SUBJECT: ACRS ASSESSMENT OF THE QUALITY OF SELECTED NRC RESEARCH
PROJECTS - FY 2015

Assessment of the Quality of Selected NRC Research Projects by the Advisory Committee on Reactor Safeguards - FY 2015

3.2 Weld Residual Stress Finite Element Analysis Validation: Part 1 – Data Development Effort

Figure 3 – Typical Results from the Double-Blind International Round Robin Program [17]

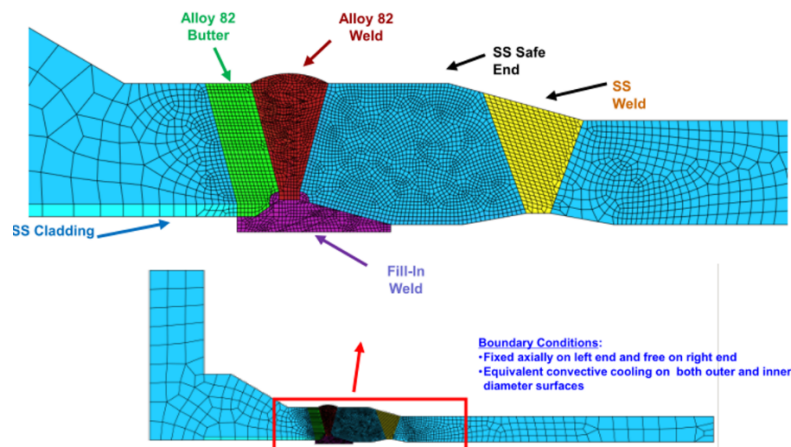
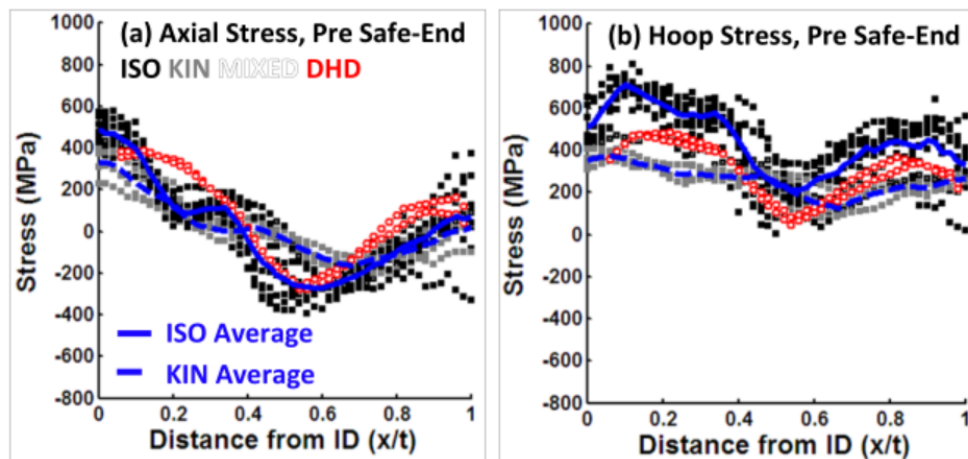
The black and grey data points in Figure 3 represent analysis results from the thirteen organizations who participated in the study, reported as stress versus normalized distance from the inside surface (x/t) at a section through the center of the Alloy 82 weld (purple region in Figure 2).

Reviewing the plots, it is seen that both the analyses and measurements predicted very high tensile WRS near the inside surface of the weld ($x/t = 0$), well above the yield strength of the Alloy 82 material (~ 265 MPa). That is, of course, consistent with the observation of SCC in numerous nozzles of this type. There is reasonable agreement in the average trends of the analyses (characterized by the blue curves) and the experimental measurements (red curves). Somewhat disconcerting, however, and indicative of the challenges faced in this validation effort, is the large degree of scatter among the analytical results; the range of individual results deviated from the averages by as much as 200 MPa in some cases.
